Model: General (GW Models)		Date: 20-Dec-01	No.: RGene010
Subject: Series Print Mode		Prepared by: K. Misugi	
From: Technical Services Dept., GTS Division			
Classification:	<input checked="" type="checkbox"/> Troubleshooting	<input type="checkbox"/> Part information	<input type="checkbox"/> Action required
	<input type="checkbox"/> Mechanical	<input type="checkbox"/> Electrical	<input type="checkbox"/> Service manual revision
	<input type="checkbox"/> Paper path	<input type="checkbox"/> Transmit/receive	<input type="checkbox"/> Retrofit information
	<input type="checkbox"/> Other (      )

Model: Model U-P1		Date: 20-Dec-02	No.: RG071001
Subject: Image Skew		Prepared by: H.K.	
From: Technical Services sec. Service Planning Dept.			
Classification:	<input checked="" type="checkbox"/> Troubleshooting	<input type="checkbox"/> Part information	<input type="checkbox"/> Action required
	<input type="checkbox"/> Mechanical	<input type="checkbox"/> Electrical	<input type="checkbox"/> Service manual revision
	<input type="checkbox"/> Paper path	<input type="checkbox"/> Transmit/receive	<input type="checkbox"/> Retrofit information
	<input type="checkbox"/> Other (      )

Model: Model U-P1

**Field Action 3**

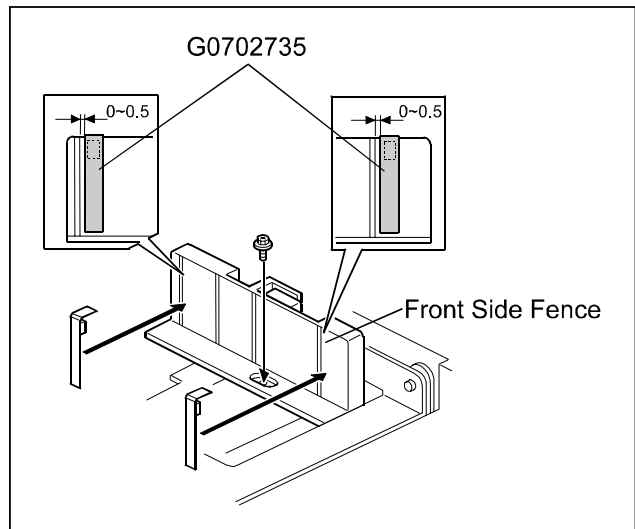
The following sheets of Mylar have been added to the side fence from the September production machines. For the field machines, please refer to the procedure below.

Page 3.23

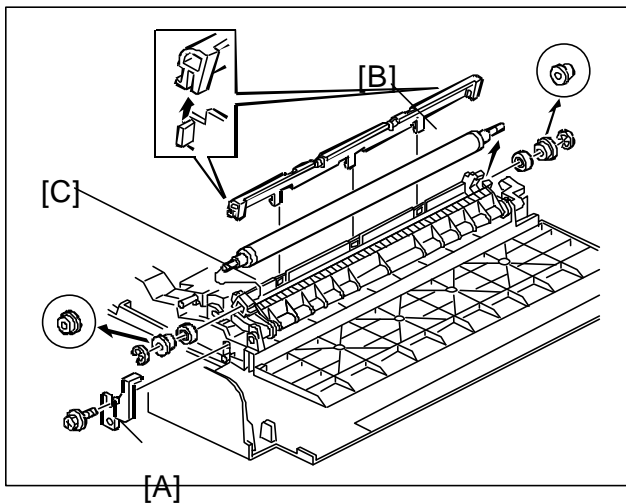
The orientation of both bearings in the illustration below should be reversed.

**Note:** This is an illustration correction only. The procedure itself is unchanged.

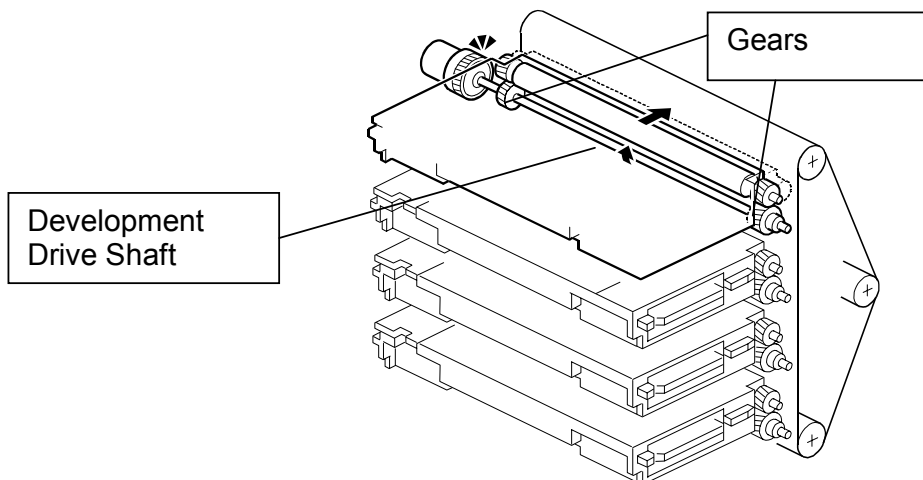
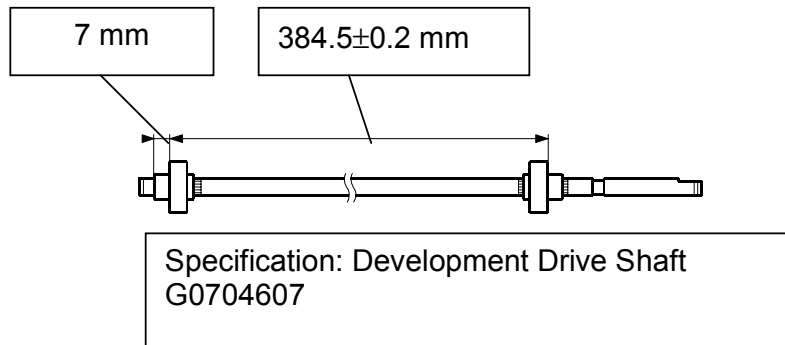
Almost all white copies & prints, or light image for one or more of YMCK colors.

The gear on development drive shaft shifts due to production line errors. Specifically:

Replace the development shaft with the spare part (G0704607: Development Shaft - FC).

### **Action 2 (trapezoid image or skewed + trapezoid image of trimming pattern)**

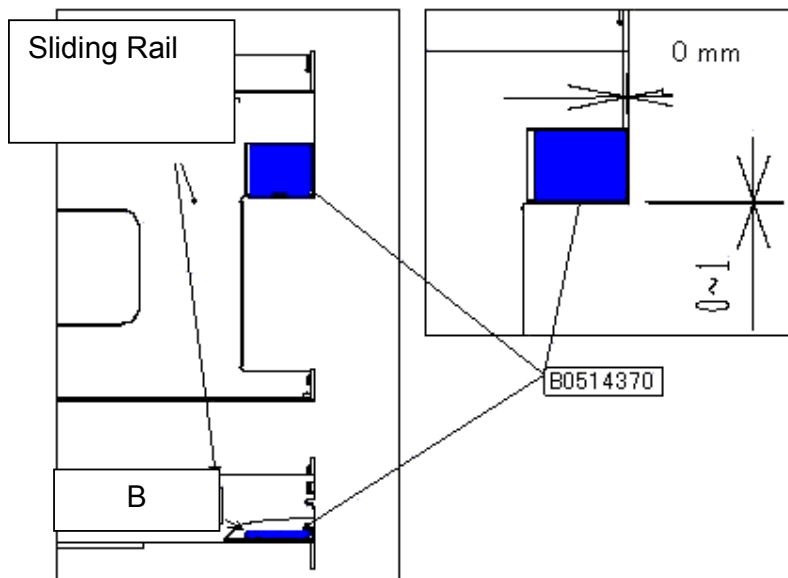
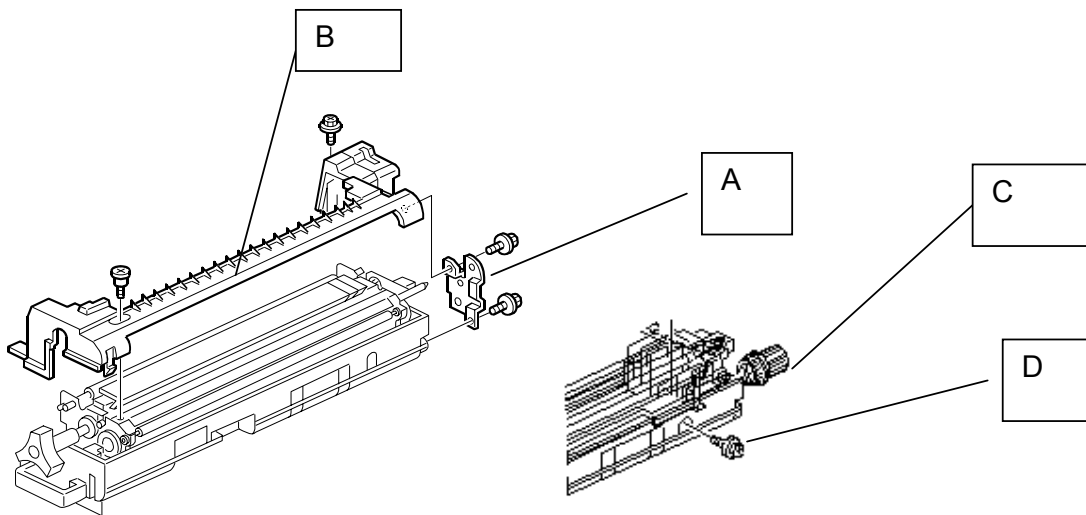
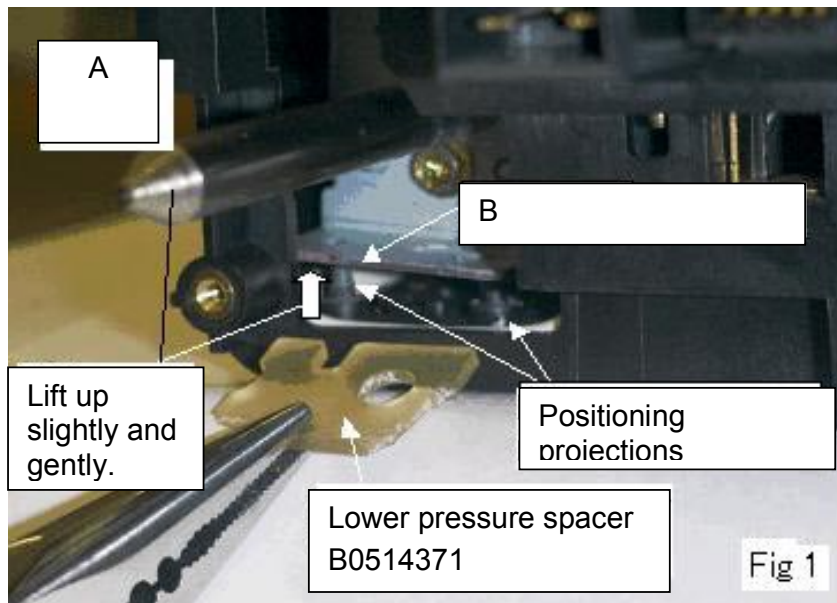
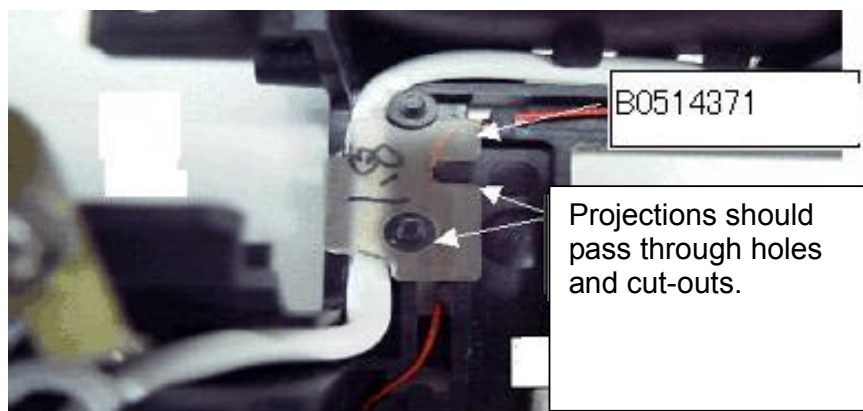
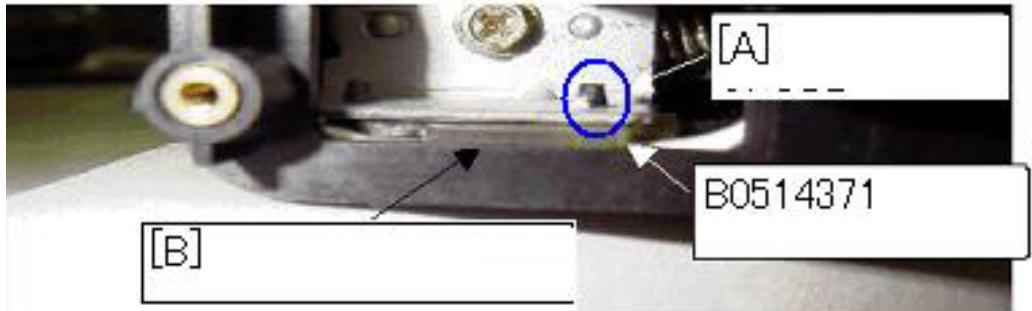
Attach the following two spacers to the fusing rail and fusing unit as shown below.  
Applied from: May 2003 production.

1. Remove the fusing unit.
2. Clean the attachment area for the rail spacer with alcohol.
3. Attach the rail spacer (B0514370) to the rear of the non-sliding fusing rail [A] so that the tapered side [B] is facing the front.

1. The actual color of the B0514370 service part rail spacer is black.
2. After attaching the spacer, move the fusing unit along the rail to make sure the spacer does not interfere with the rail.

1. Remove the fusing unit. Then, remove the oil supply unit.
2. Remove the gear bracket [A] (2 screws).
3. Remove the upper cover [B] (2 screws, 1 shoulder screw).
4. Remove the drive gear [C].
5. Remove the pressure side plate securing screw (rear side only) [D].

6. Lift up the shaft [A] very gently, just enough so that the lower pressure spacer can be inserted. While holding the shaft up, insert the lower pressure spacer (B0514371) between the pressure side plate [B] and lower cover.

**Note:** Insert the spacer so that the positioning projections can pass through the hole and cut-outs in the spacer (see the illustrations below).

- Positioning projection [A] is visible
- The edge of the lower pressure spacer (B0514371) is aligned with the lower cover edge [B], i.e. not positioned inside or projecting out from the cover edge.

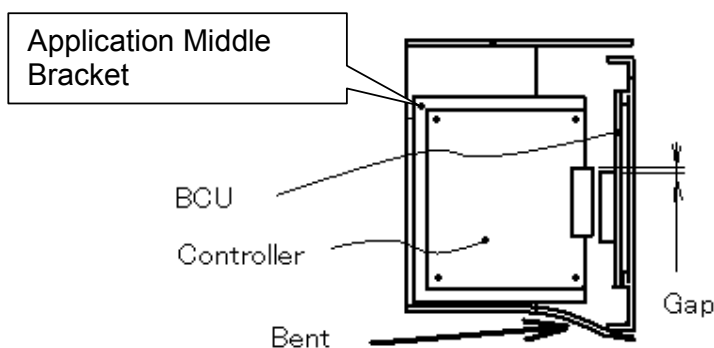
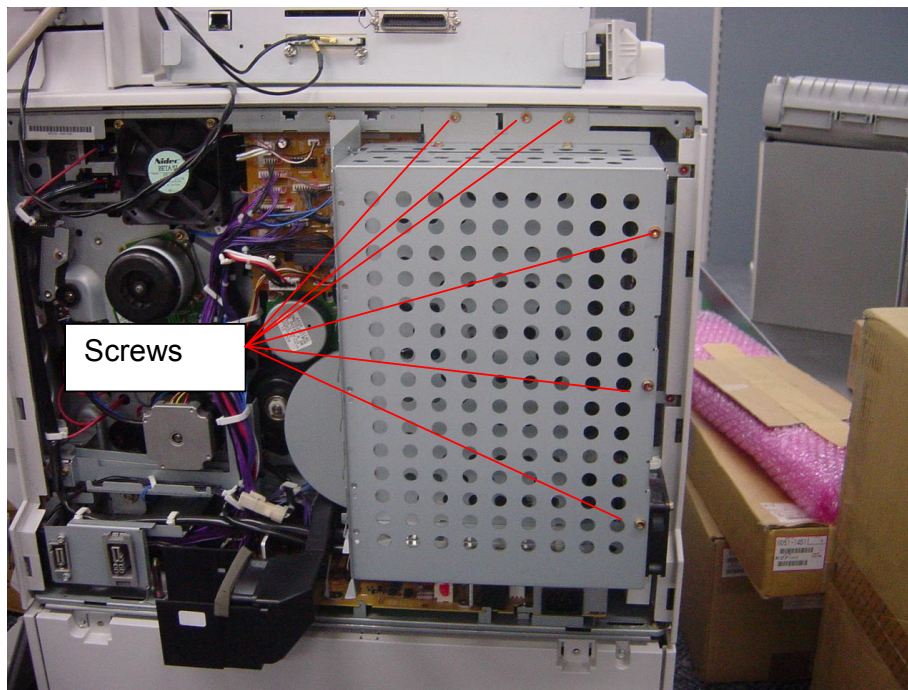
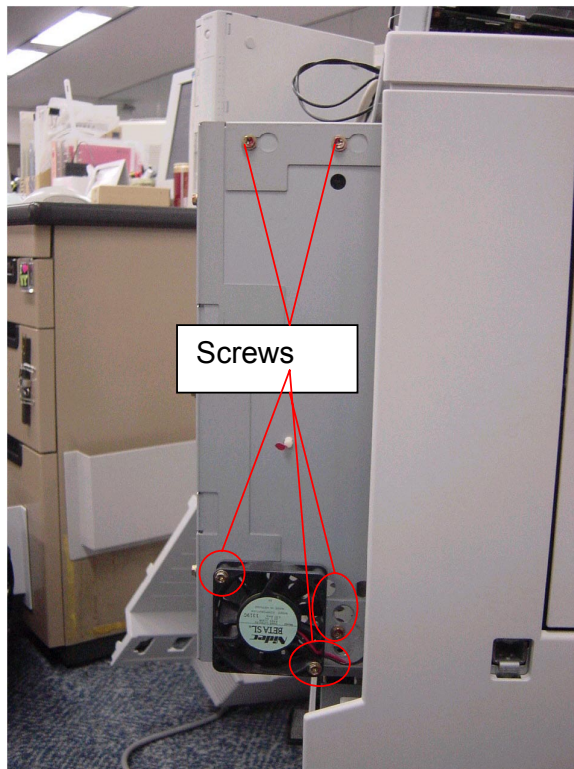
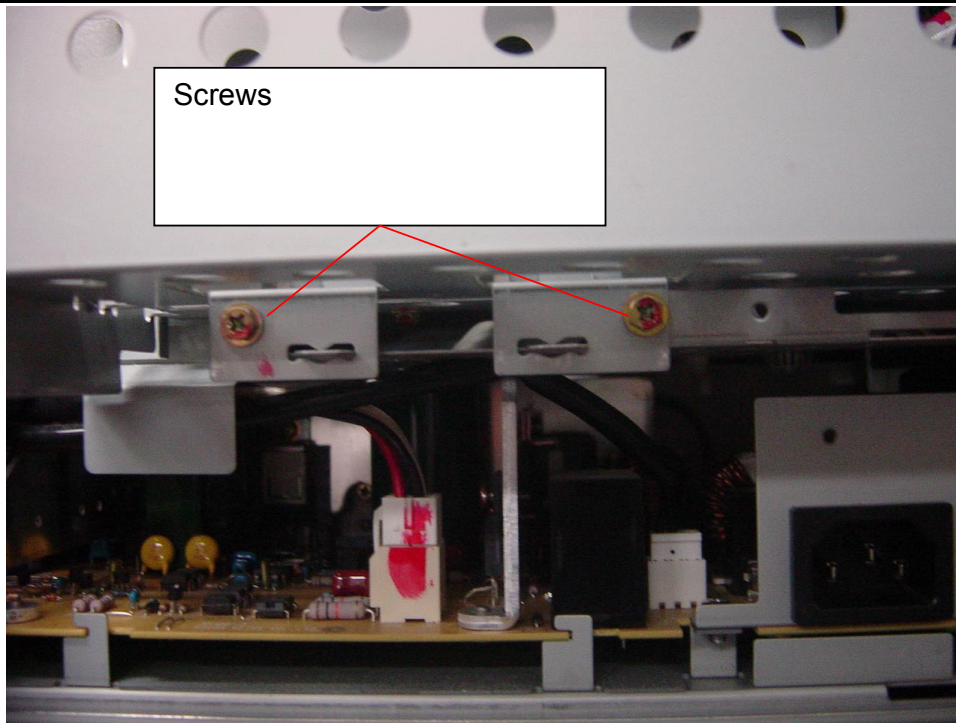
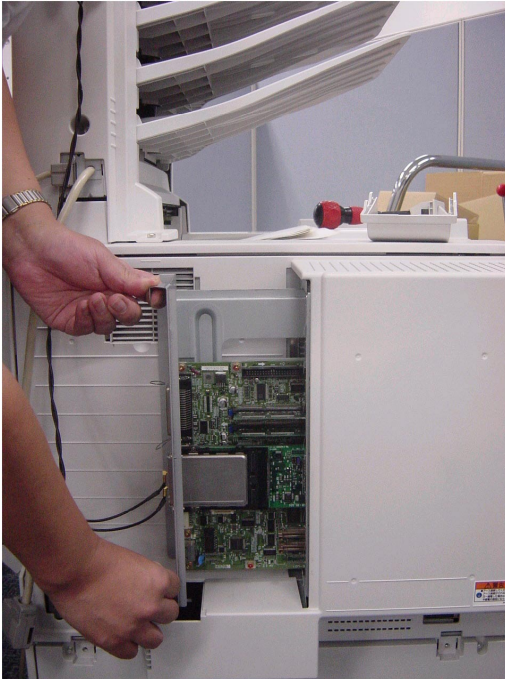
Some controller boxes were attached on the production line slightly higher than their optimal position, resulting in poor connection between the controller board and BCU board connectors.

Temporary (from mid-October 2003 production):

The screws for the controller box are secured while the controller box is held in the proper position.

1. Turn off the main switch and remove the duct cover, ozone filter, printer controller, and rear cover.
2. Loosen the 13 screws that secure the controller box and cooling fan.

3. While holding the controller box in its lower position, secure the 13 screws.

**Point:** The controller box is attached in this lower position to prevent poor connection between the BCU and controller. If the controller box is assembled in the upper position, a poor connection may occur.

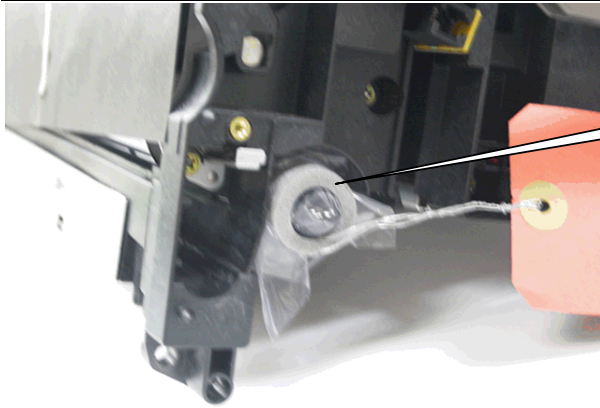
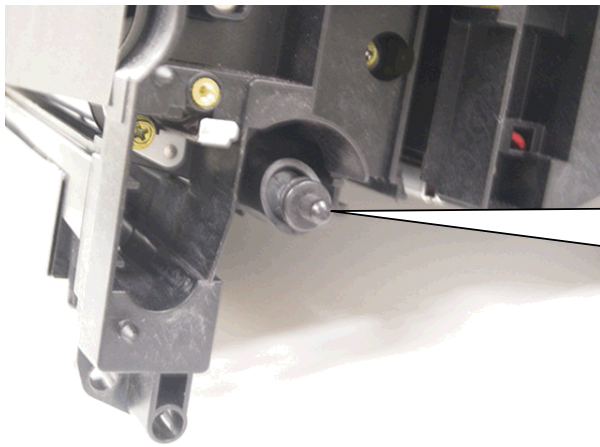
- PCU cleaning was added to the production process for the maintenance kit PCU. Applied from: May 2003 production.
- A cap has been added to the maintenance kit PCU to seal the opening between the PCU and waste toner bottle during shipping. Applied from: B3173910025 (G780-17).

1. This cap is not necessary on mainframe PCUs since the O/B waste toner bottle already covers this opening (see **Important Note** below).
2. The Installation Procedure in the PCU Maintenance Kit has been modified to include the **Important Note** below. If any inquiries are received regarding the above symptom, please advise customers using this note.

Please be sure to remove the cap [A] before installing the unit.

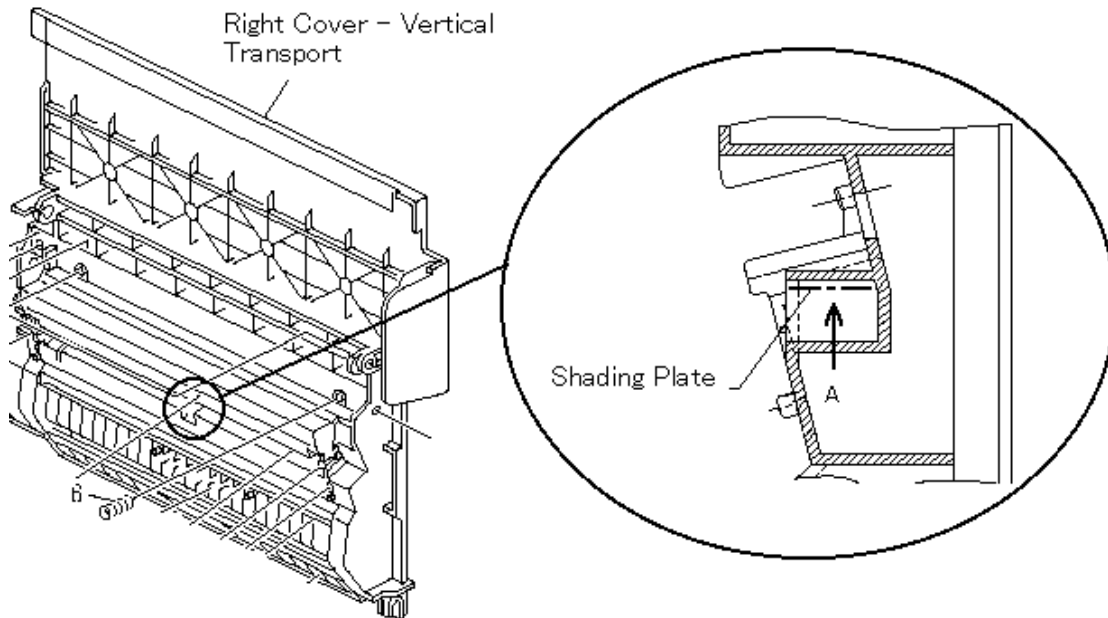
Continuous paper jams at the registration section (counted in SP7504-63). Although the paper is caught, there are no marks visible.

Paper dust in the machine reflects and diffuses light, which causes a registration sensor misdetection and the jam condition.

Clean the area shown in the illustration, and remove any sheets of paper still left in the registration area.
